November 5, 1993

SUBJECT: Response to FDEP Request for Information
Regarding: Operating Permit Application Renewal
Permit No. UO 56-237554
North Port St. Lucie Injection Well IW-1

On behalf of St. Lucie County Utility Services Department (SLCUSD), Montgomery Watson is pleased to submit three copies of the response to the Florida Department of Environmental Protection (FDEP) Request for Information (RFI) regarding Operating Permit Application for Injection Well IW-1 at the North Port St. Lucie Injection Well System, Permit No. UO 56-237554, dated October 8, 1993.

FIGURE 2-5.
 GDU North Port St. Lucie WWTP—Generalized North-South Geologic Section
 from Indian River to Martin County. **CH2M HILL**

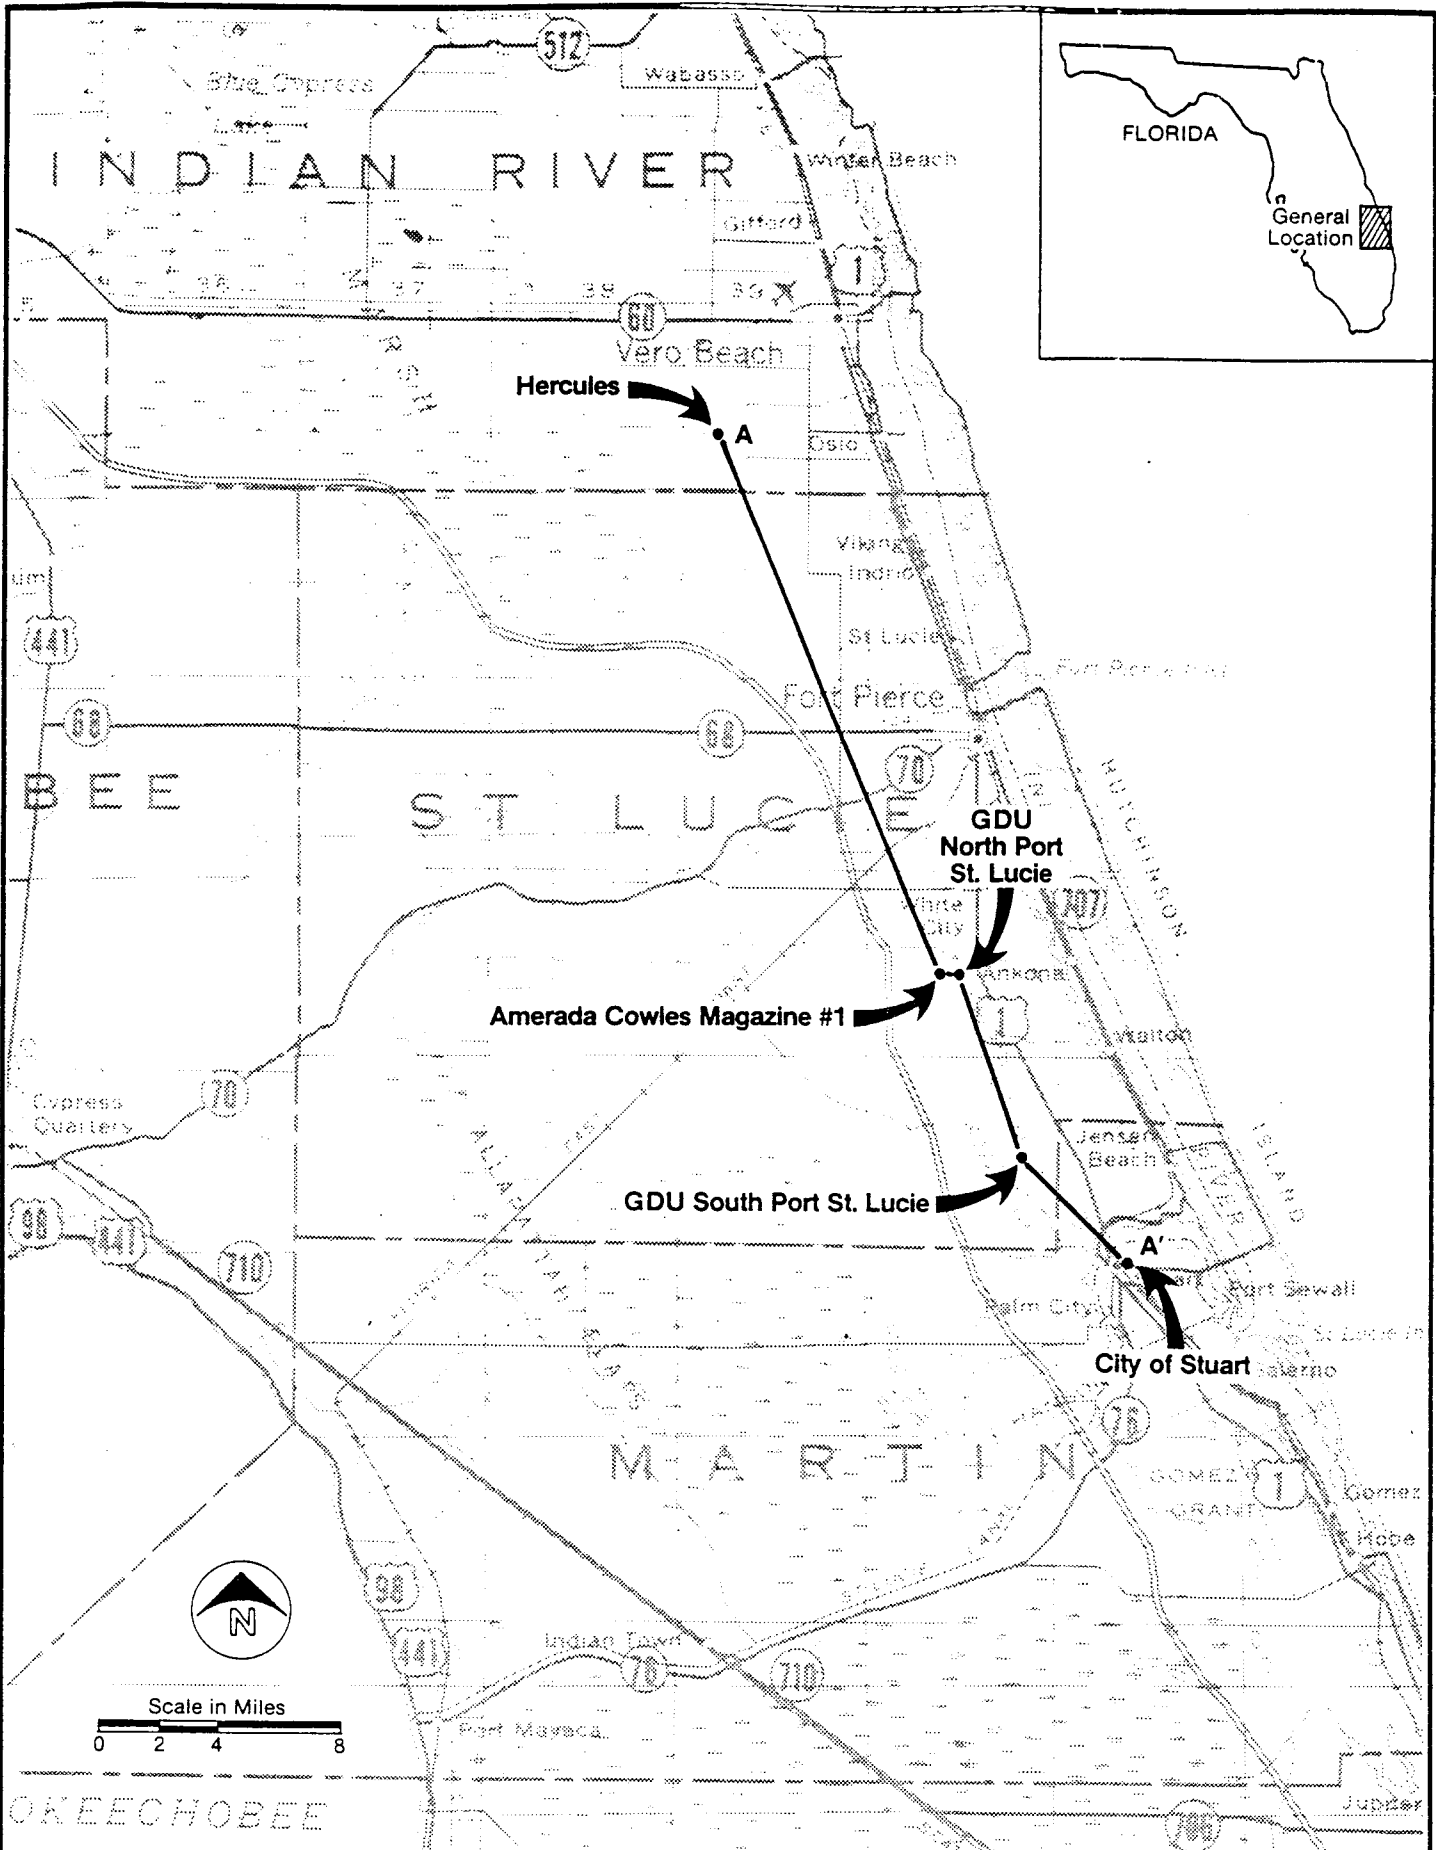
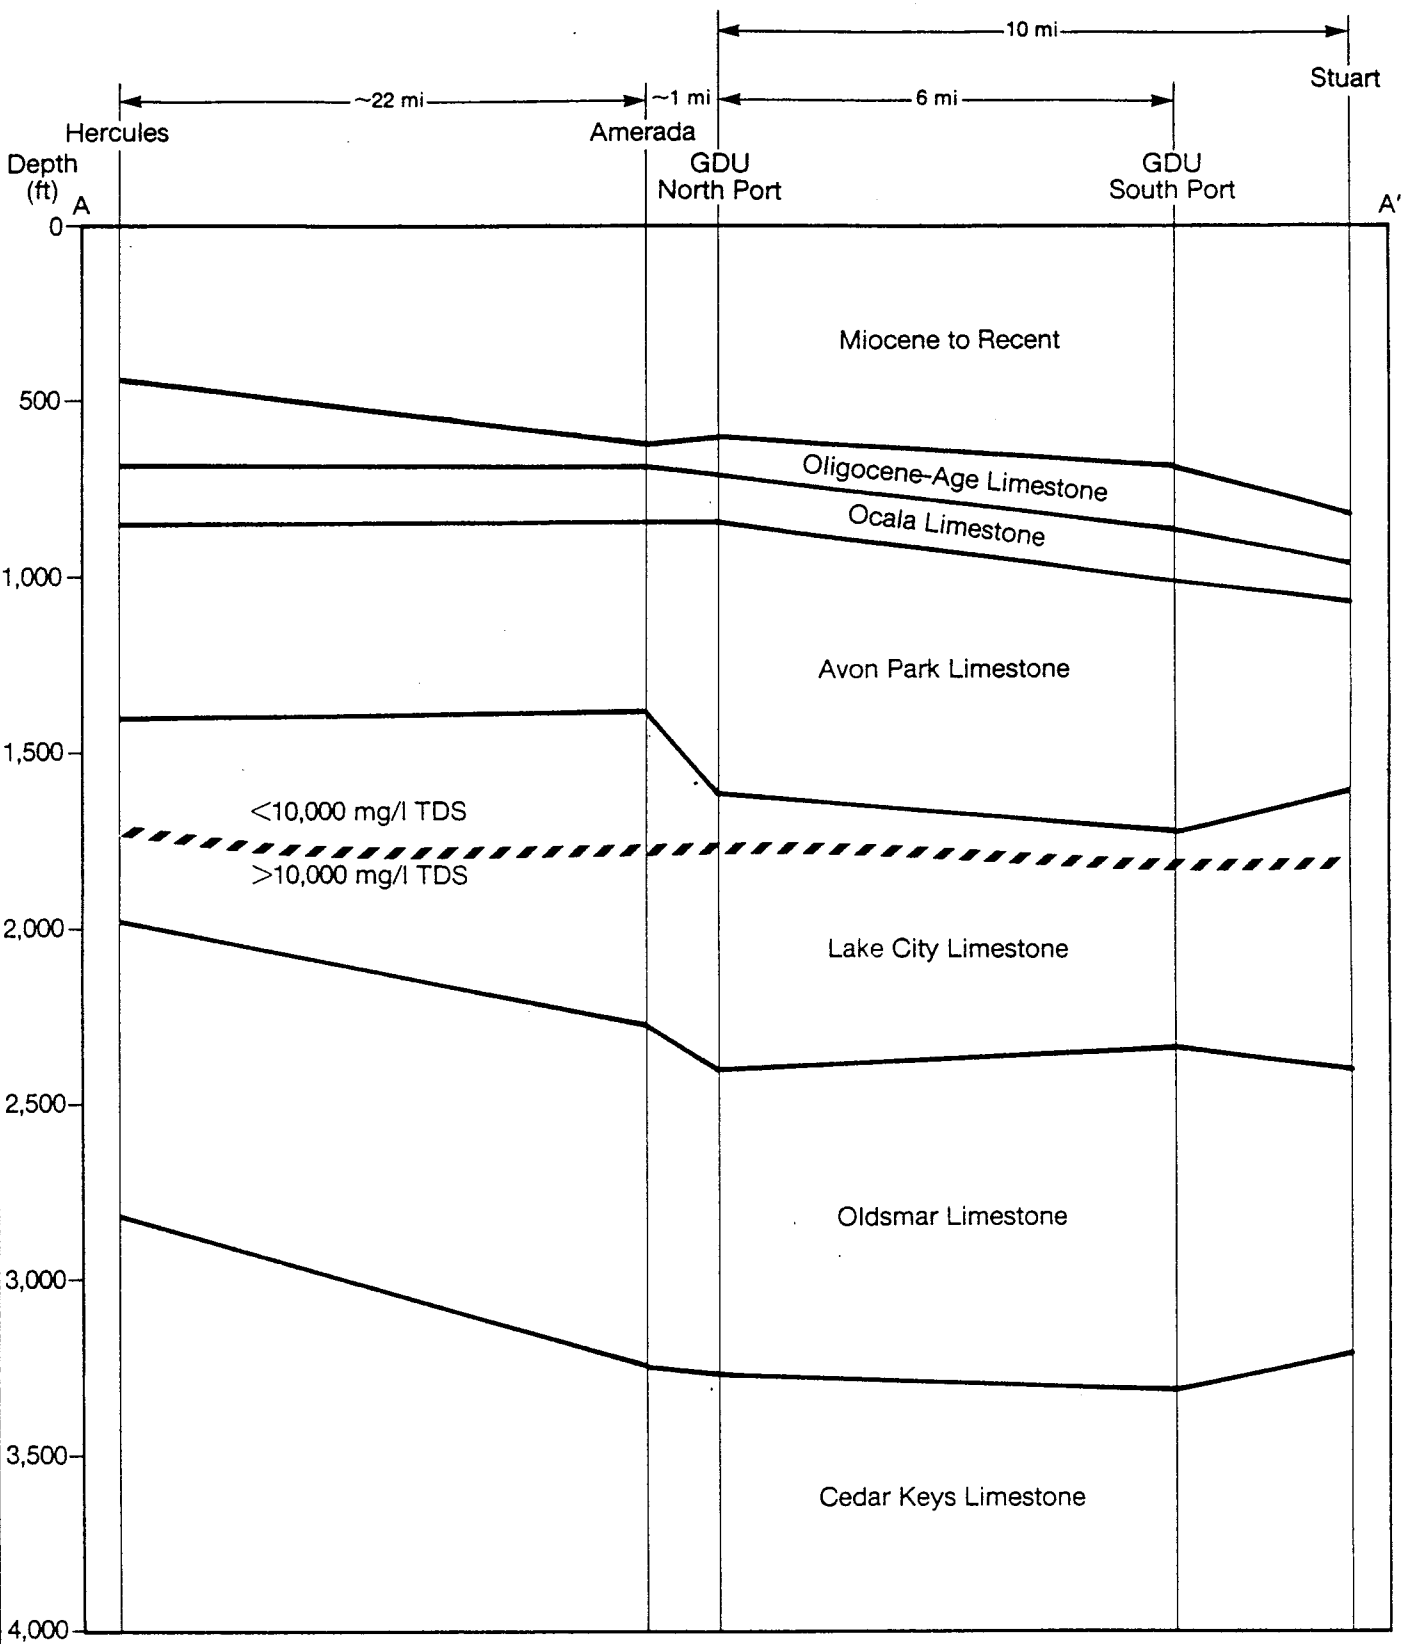
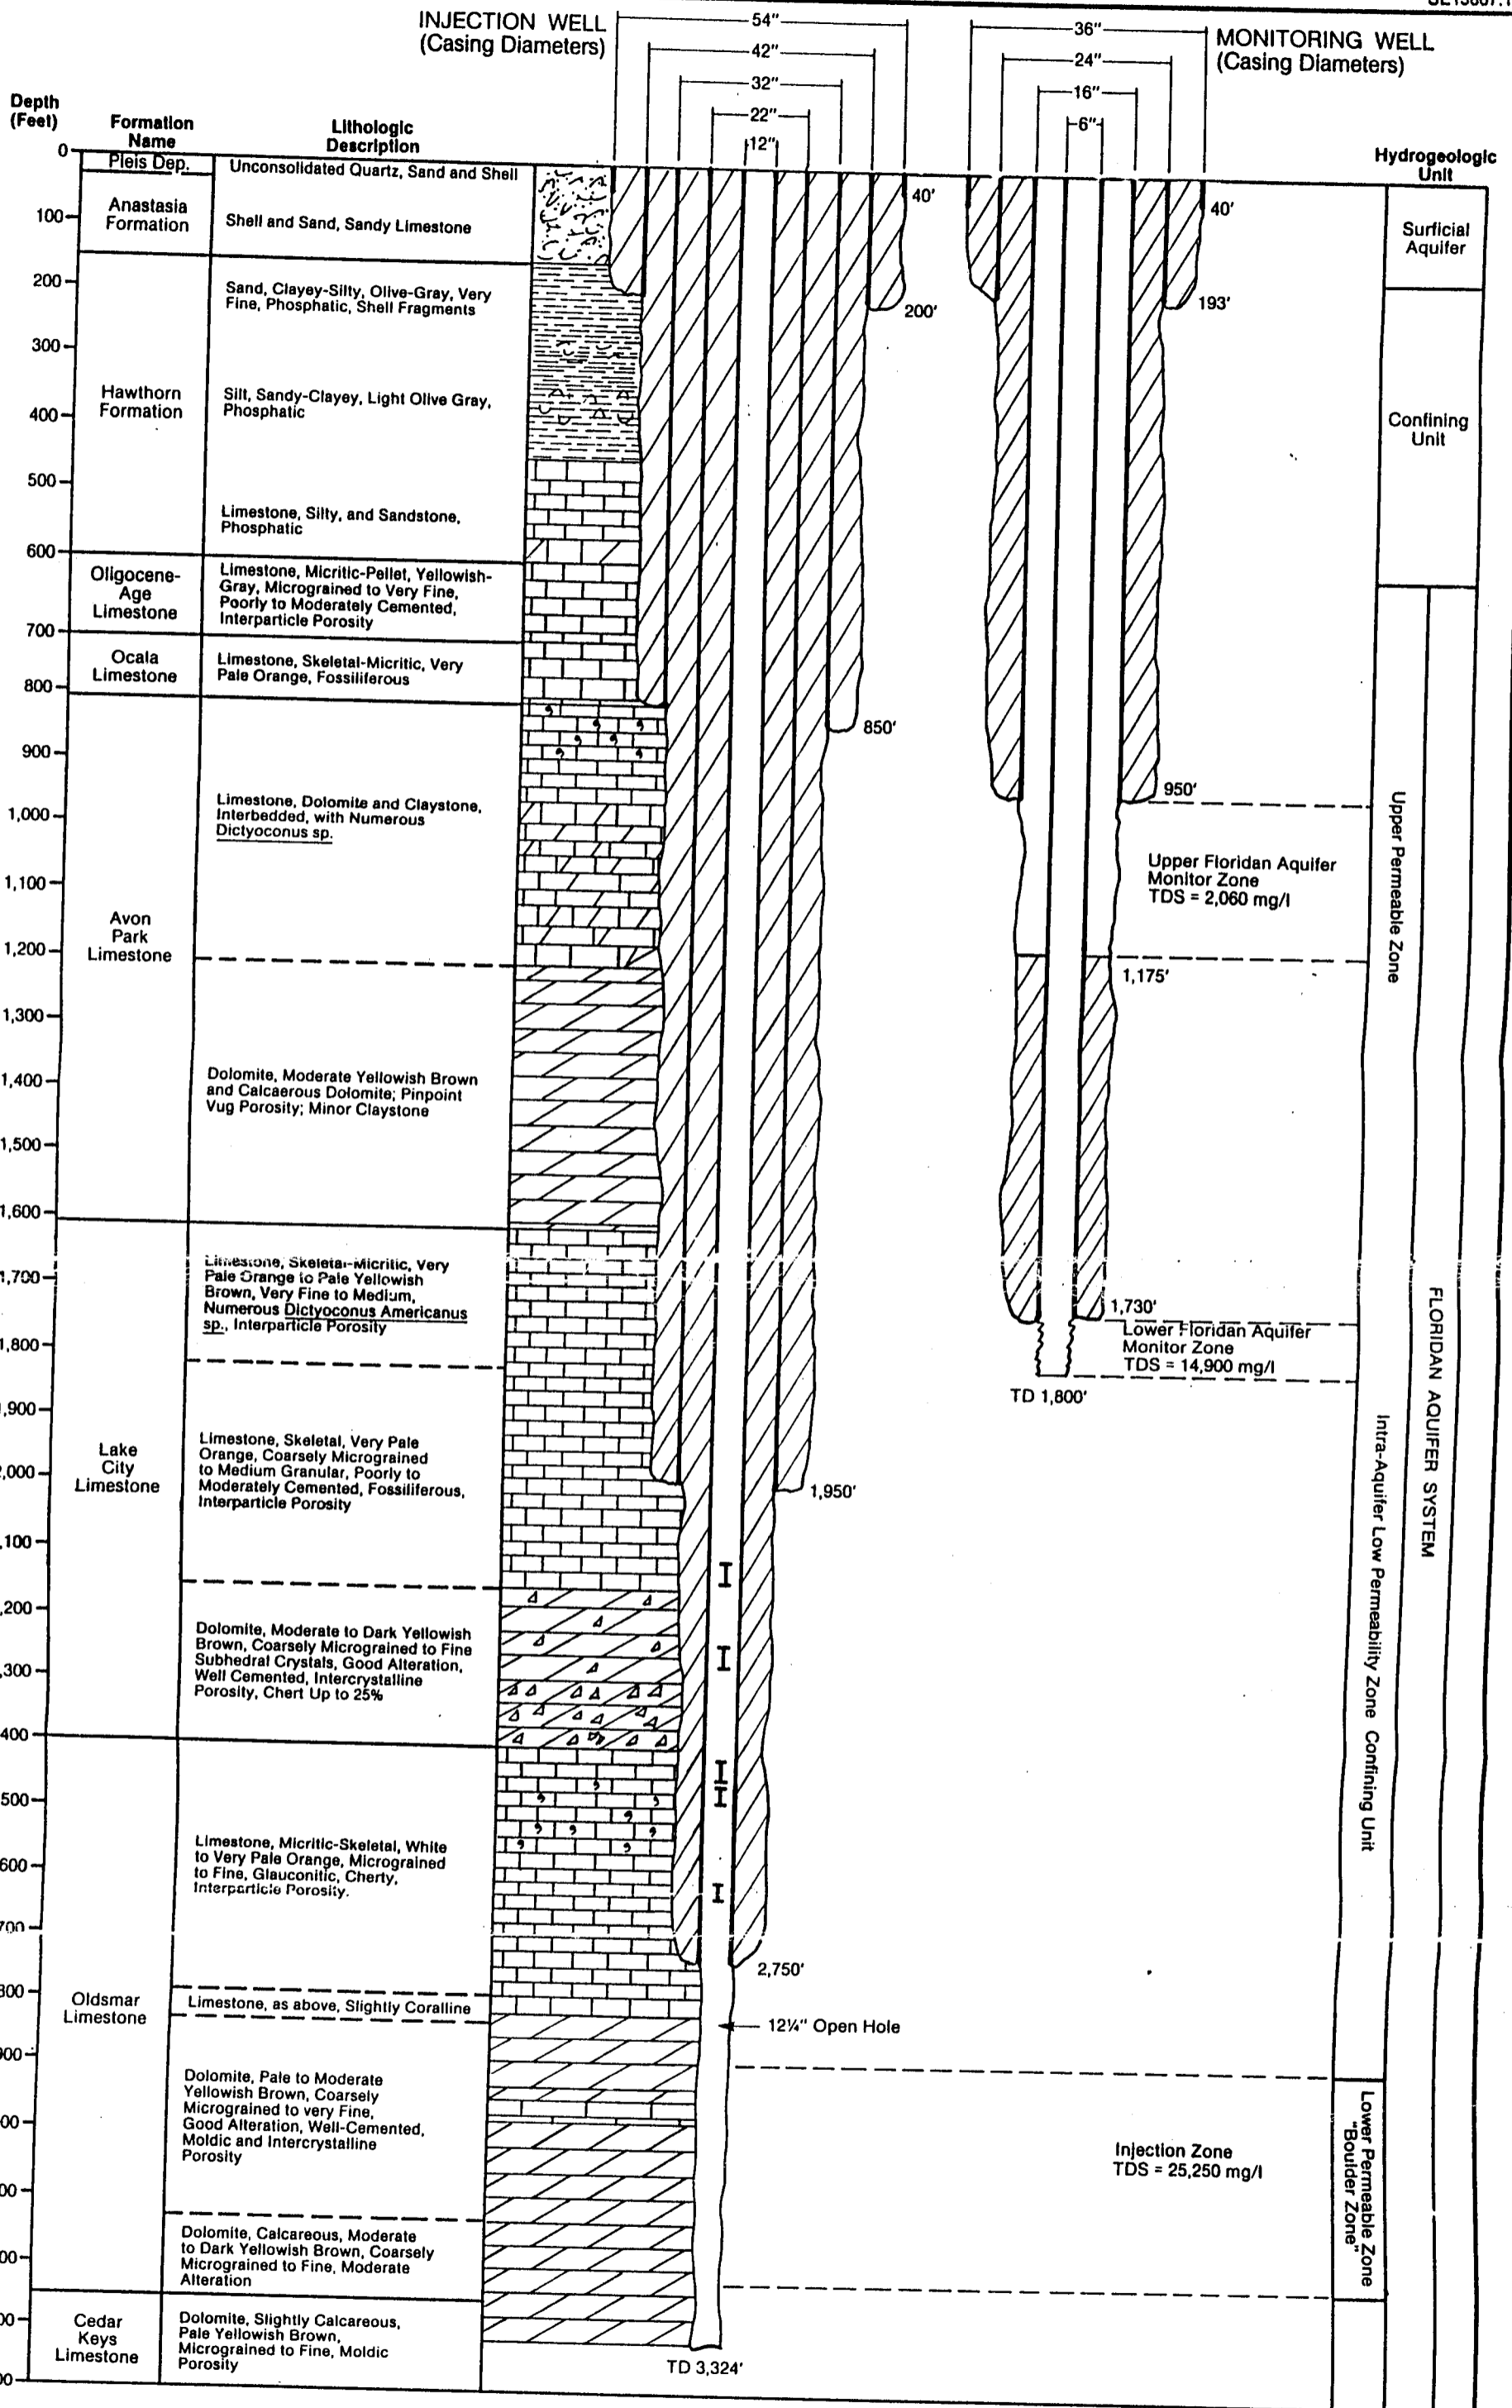
- 2. As required by Rules 17-28.210(1) (a) and (2) (a), F.A.C., an applicant for an injection well shall demonstrate the adequacy of confinement between the injection zone and the zones above the injection zone. This data will come from the information obtained during construction of the wells, but as required by Rule 17-28.340(1) (c), F.A.C., must be provided in this application so that it can be approved on its own merit. Within the area of review, maps and cross sections detailing the local geology and hydrogeology including the vertical and lateral limits of all underground sources of drinking water (USDW) are needed. Maps and cross sections illustrating the regional geologic setting are also needed.**

Maps and cross sections of the regional geologic setting, from the initial Operating Permit Application for Injection Well IW-1 at the NPSLIWS, are provided in Attachment E. Cross sections of local geology and hydrogeology are provided in Attachment F, Figure 2-3, from the CH2M Hill report entitled "Drilling and Testing of the Deep Injection Well System," dated October 1987.
